AccurIC Ltd second submission to 14-BSTD-1 (Title 24, building code)

**California Energy Commission 2014 Appliance Efficiency pre-ruling
Comments of AccurIC Ltd, via docket number 14-AAER-1 in relation
to the proposed Voluntary California Quality LED Lamp
Specification**

Figure 1: Proposed maximum LED flicker mask, for limiting biological effects (currently under consideration by IEEE Working Group PAR1789)

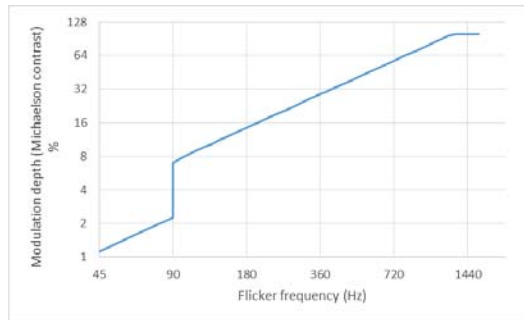
We strongly suggest, in order for a flicker performance related standard for LED lighting in the state of California to be aligned with emerging recommendations, based on peer-

reviewed research, that the maximum flicker mask shown in Figure 1 should be used as the basis for such a standard.

Figure 3: The construction of Low Pass Filter bands which, when used additively (see Table 1) provide a stepwise approximation (red line) to the draft IEEE PAR1789 maximum flicker mask

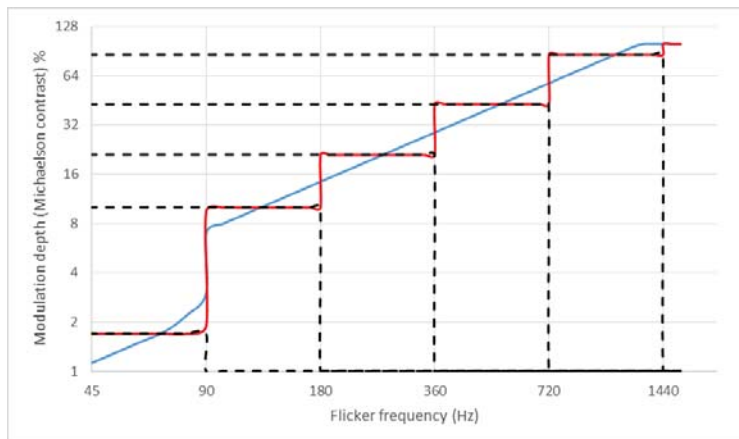
By choosing the cut-off frequencies of the low pass filters used in step 3(b) to be 90, 180, 360, 720 and 1440 Hz and defining appropriate maximum levels of modulation depth for each filter band, a stepwise approximation to the mask shown in figure 1 can be constructed. Figure 3 shows the low pass filter bands (shown as dotted lines) and the stepwise approximation to the mask (shown in red). The resulting flicker performance criteria, all of which need to be met in order to provide a sufficiently low flicker performance across all flicker frequencies, are summarised in Table 1.

Low Pass Filter cut-off frequency, f_u , Hz	Maximum Modulation depth (Michaelson contrast) %
90	1.7
180	10
360	21
720	43
1440	86

Note: In order to ensure alignment with the proposed dimmability specification, the maximum flicker (modulation depth) criteria given in Table 1 should be met at the following dimming levels: 100% (undimmed) 50%, 20% and 10%
